**ENGINEERING, OPERATIONS AND PLANNING COMMITTEE MEETING  
AGENDA**

**DATE:** January 16, 2024  
**TO:** Engineering, Operations and Planning Committee  
**FROM:** Linda Jadeski, Assistant General Manager  
**SUBJECT:** CHANGE ORDER NO. 4 WITH PCL CONSTRUCTION, INC. FOR THE OLIVER P. ROEMER WATER FILTRATION FACILITY UPGRADE AND EXPANSION PROJECT

CHANGE ORDER

Order No. 4  
Date 1/8/2024  
Agreement Date 10/31/2022  
Sheet 1 of 2

**E-2**  
 SHEET  
 64 OF 106

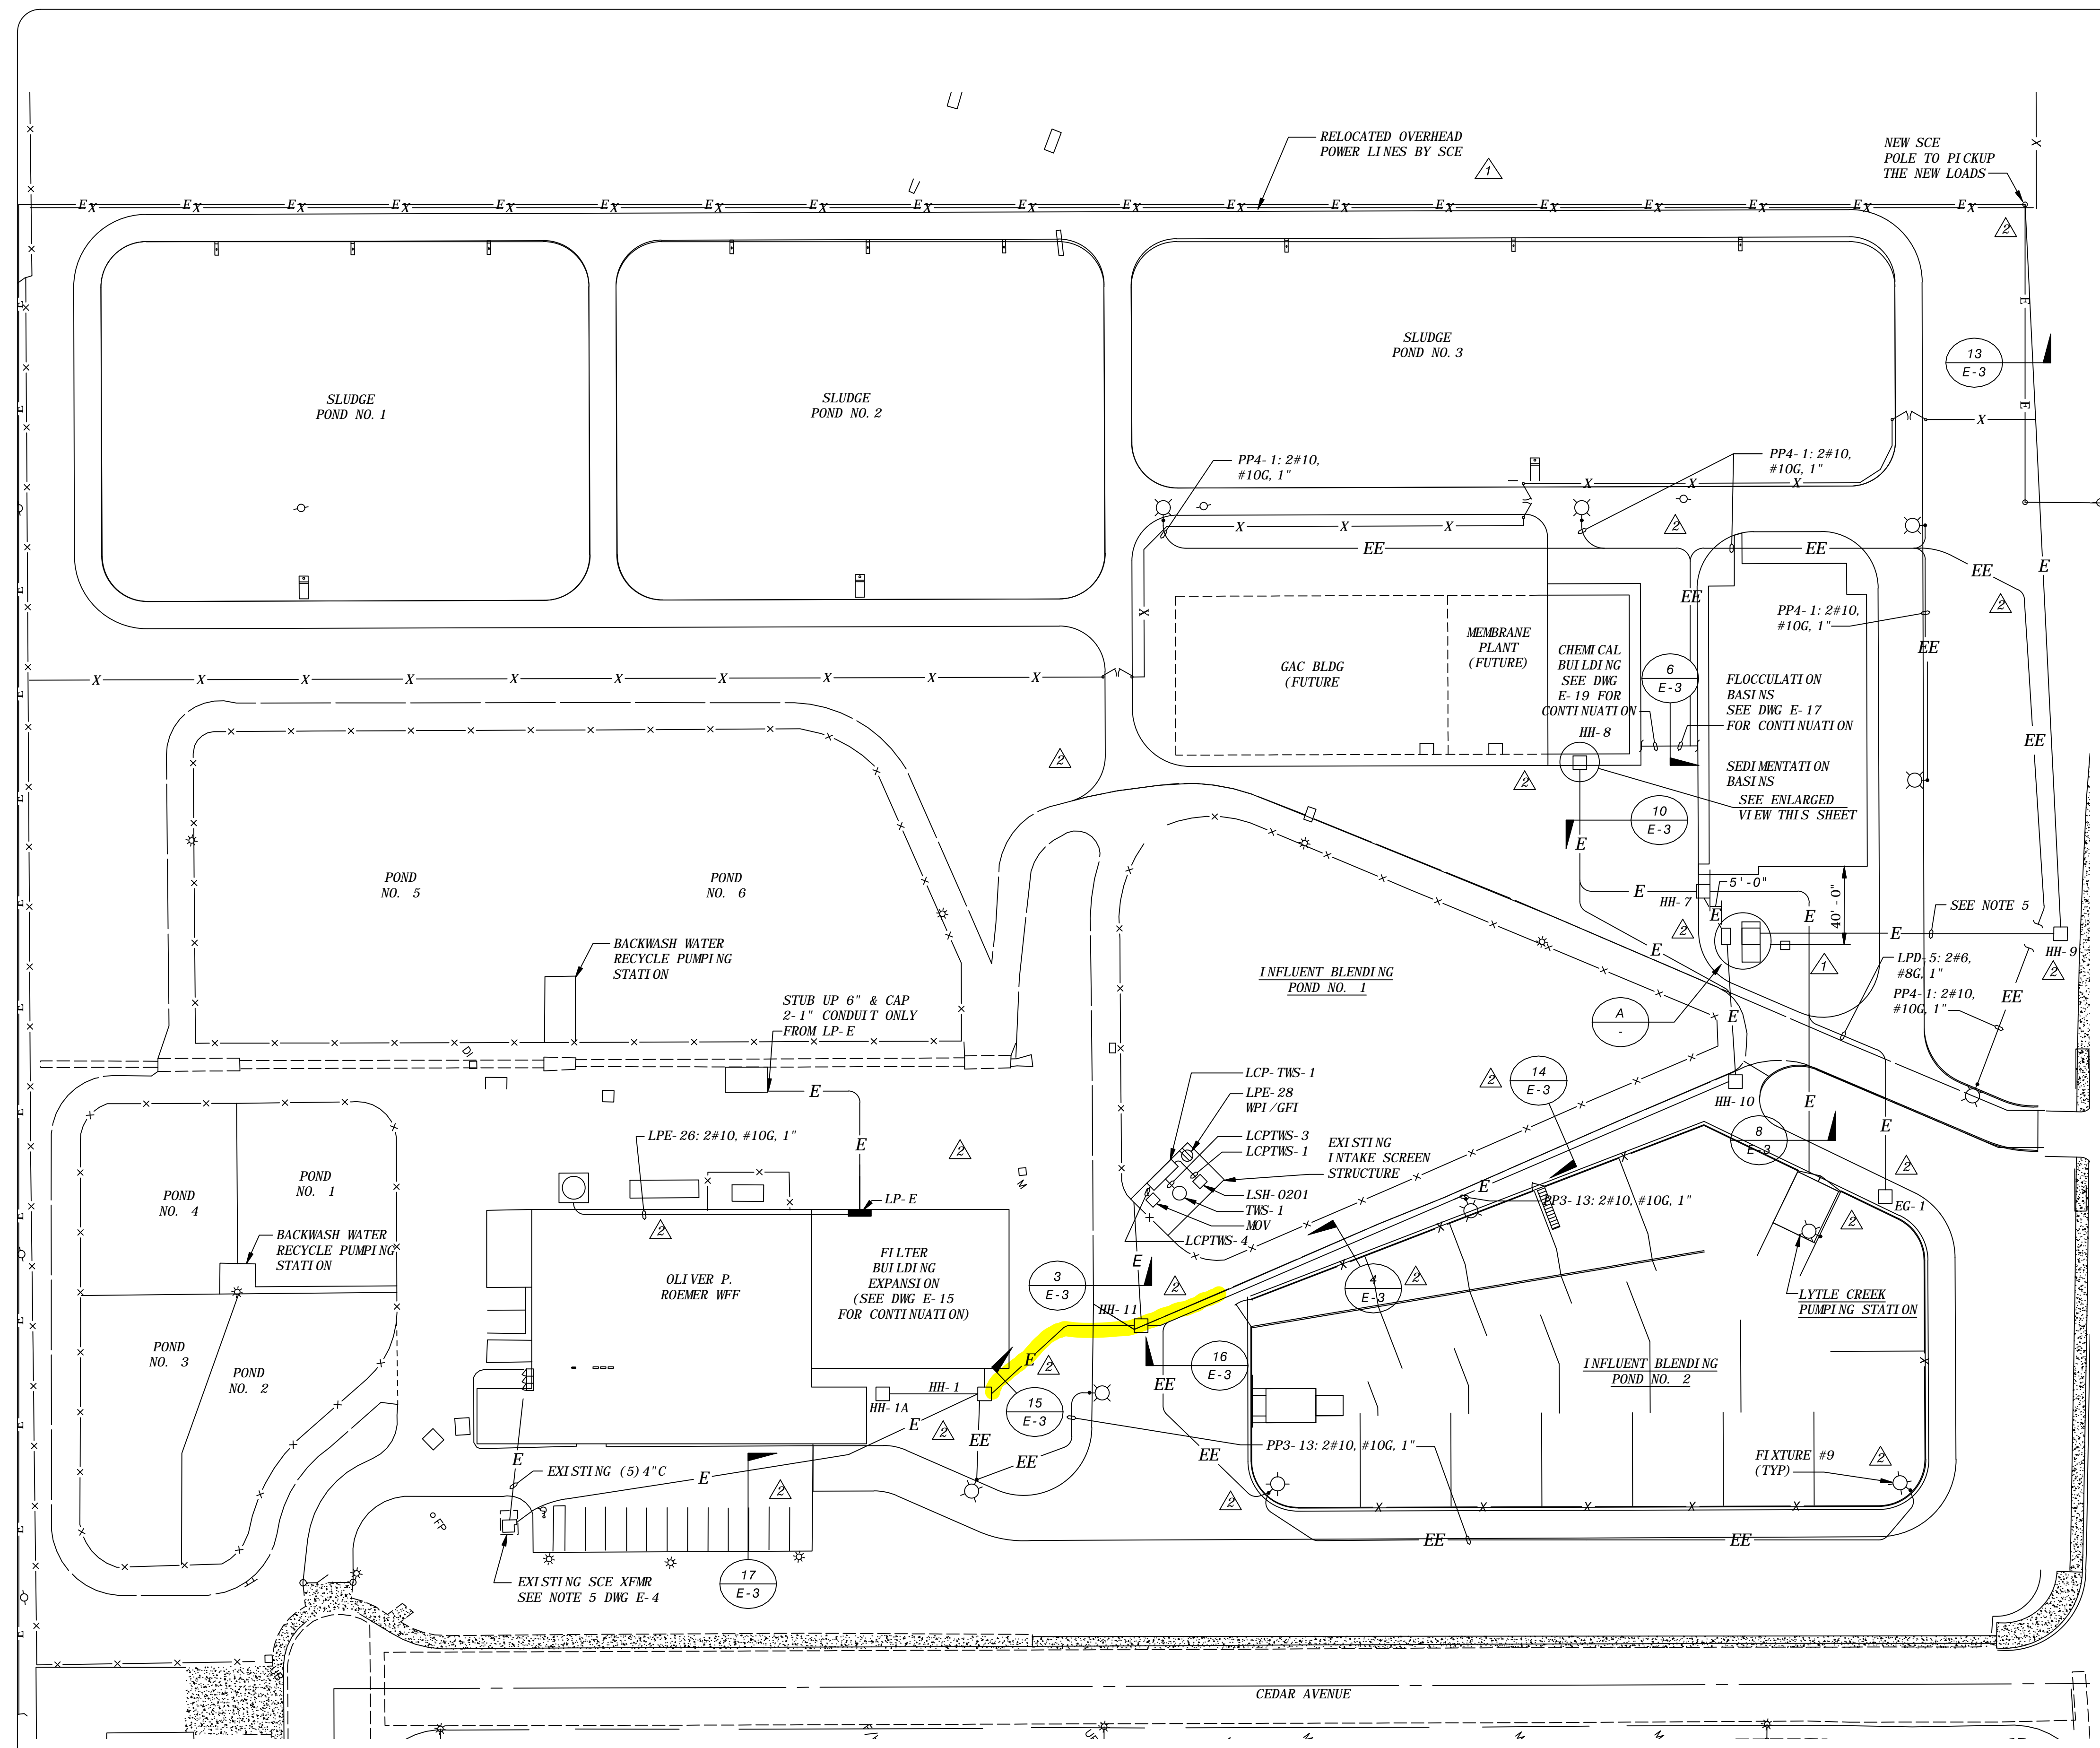
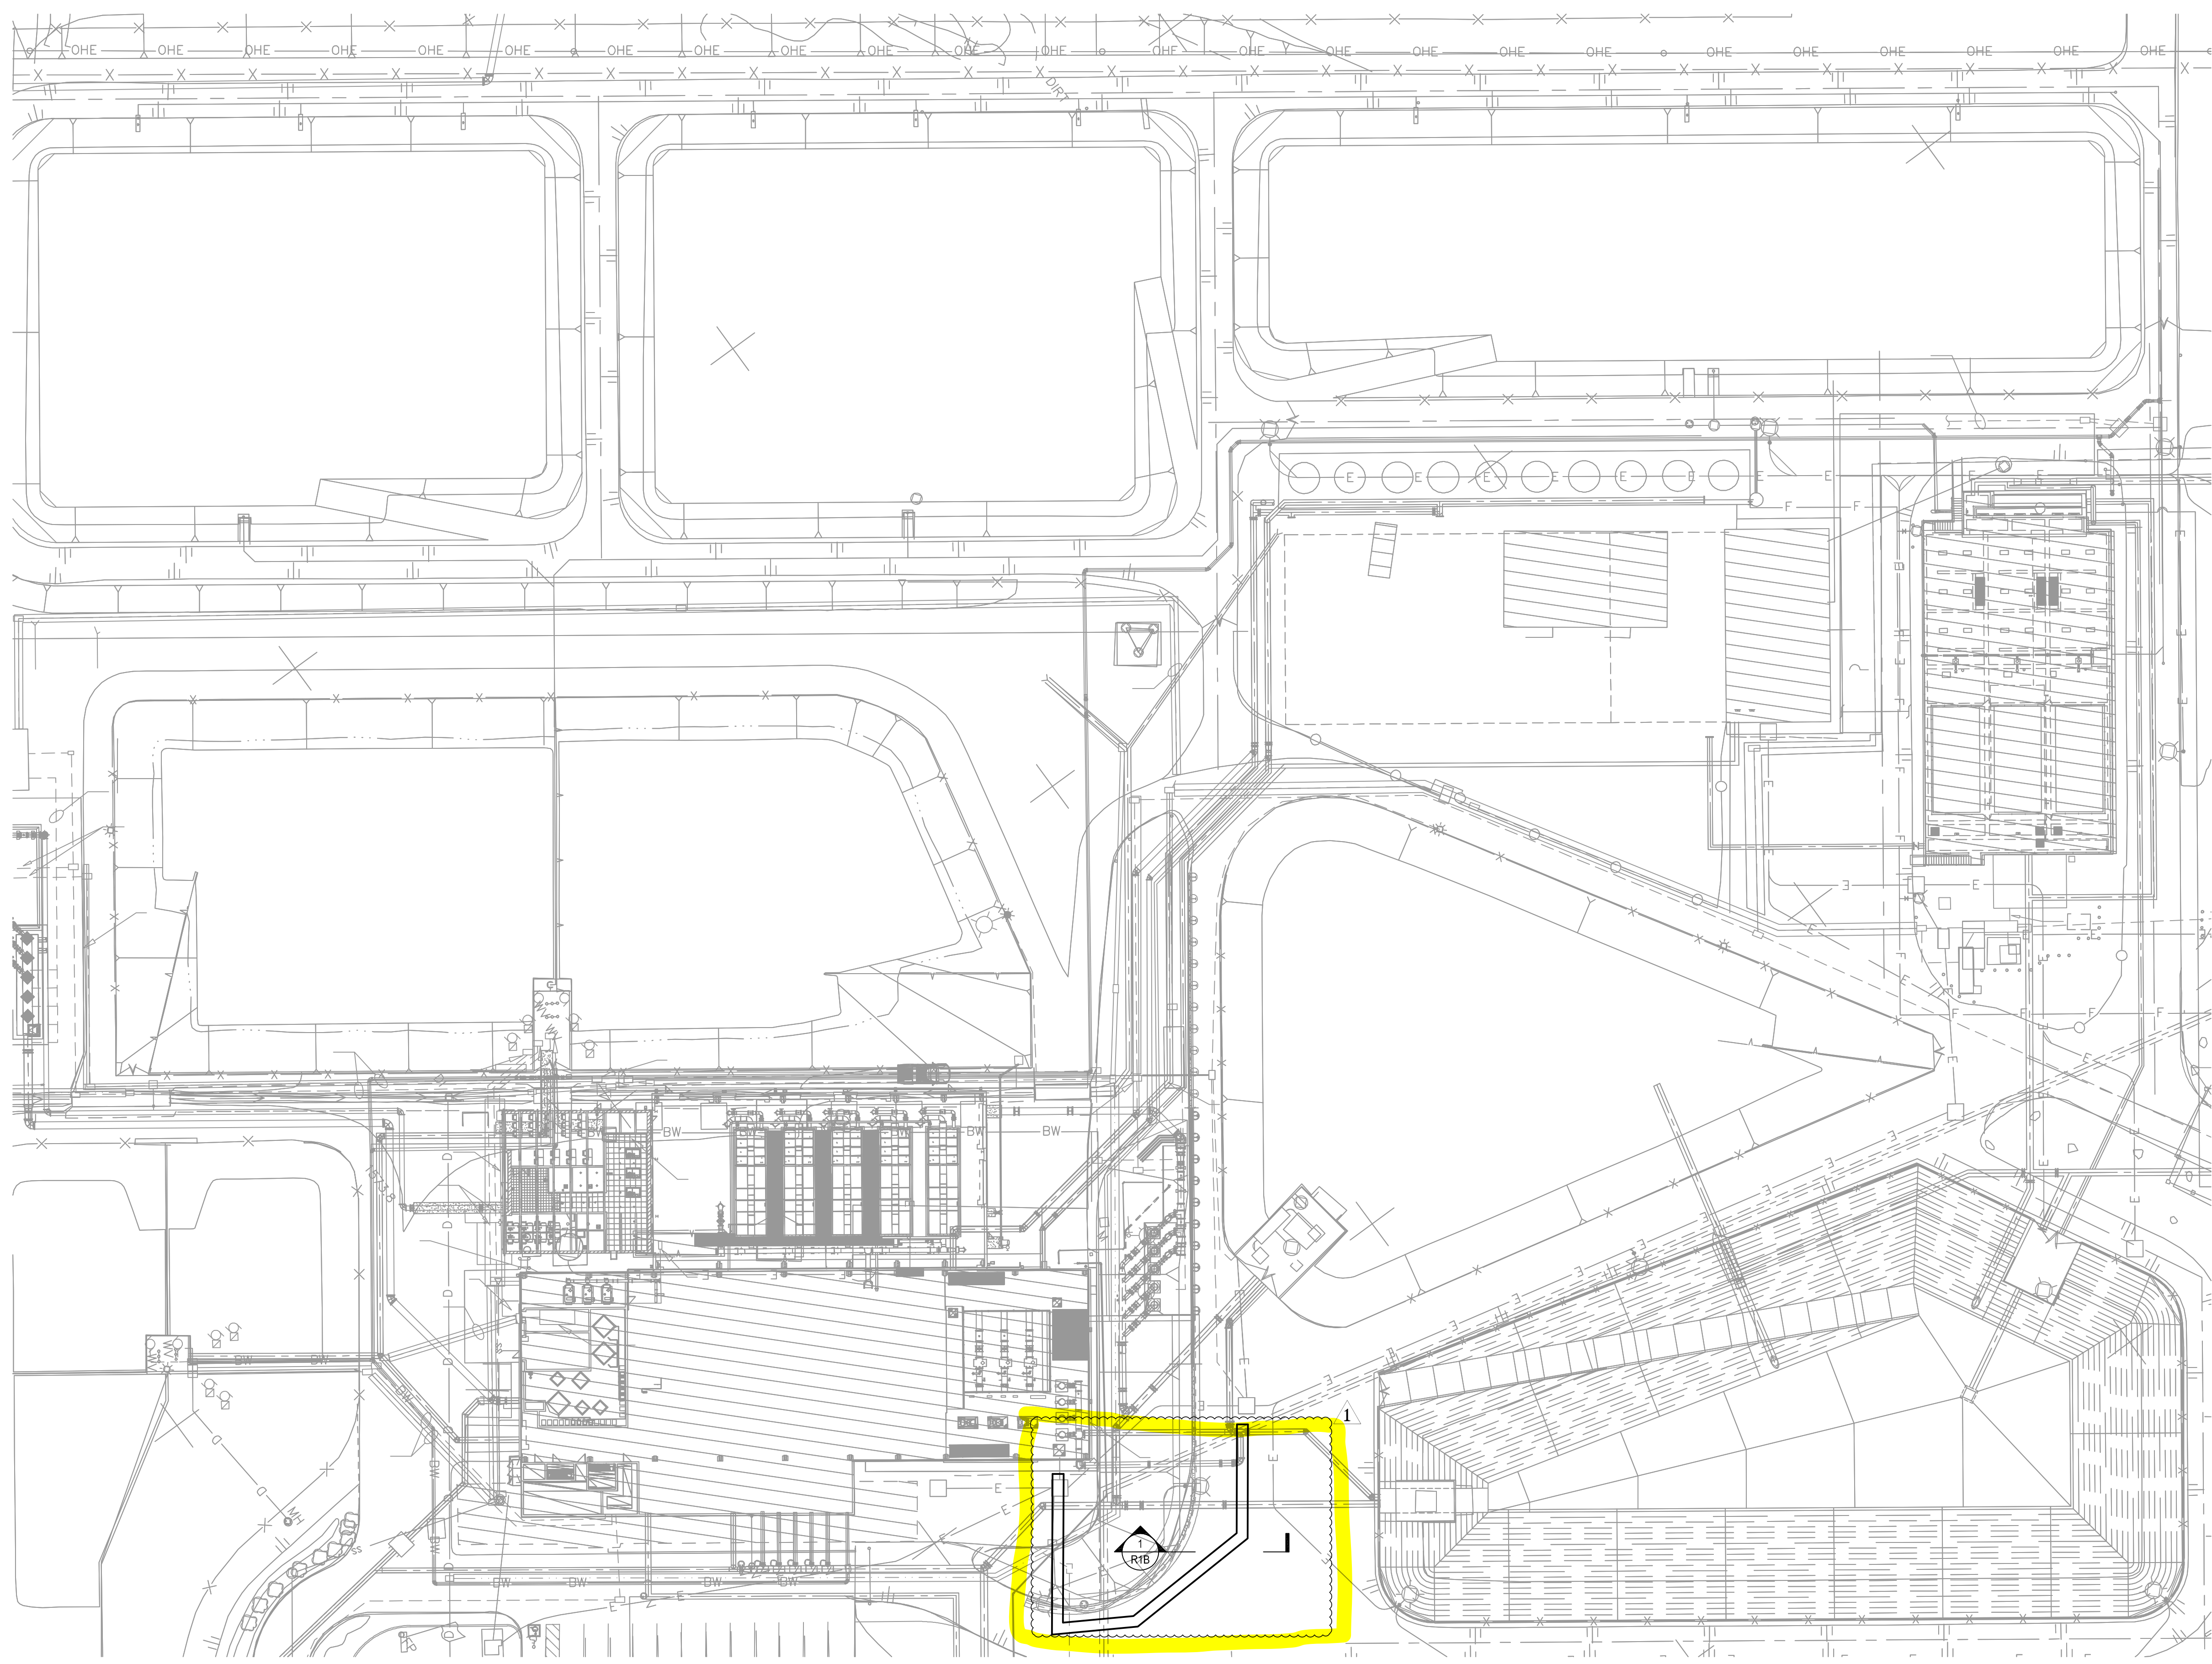
1. The Record drawing E-3 from the "West Valley Water District Oliver P. Roemer Water Filtration Facilities Expansion" set provided to PCL does not provide a profile with elevations for the ductbank between vault HH-11 and H-1. While drawing E-3 calls for a 2 feet minimum coverage for existing ductbanks, other information provided within the 30% design drawings strongly implies a deeper ductbank elevation. For instance, although the 30% design drawings have several other reroutes that are called out in the area, for example, the GAC and the 24" UV recovery lines reroutes, there are no callouts anywhere in that set nor within the Contract documents that indicate the ductbank to be rerouted. Moreover, the as-built shows a standard detail for minimum cover, which very seldom is achieved in actual ductbank runs through plants due to crossings and other factors. For instance, most of the new ductbanks that are part of PCL's scope of work do not have the minimum coverage due to insufficient clearance to existing utilities.
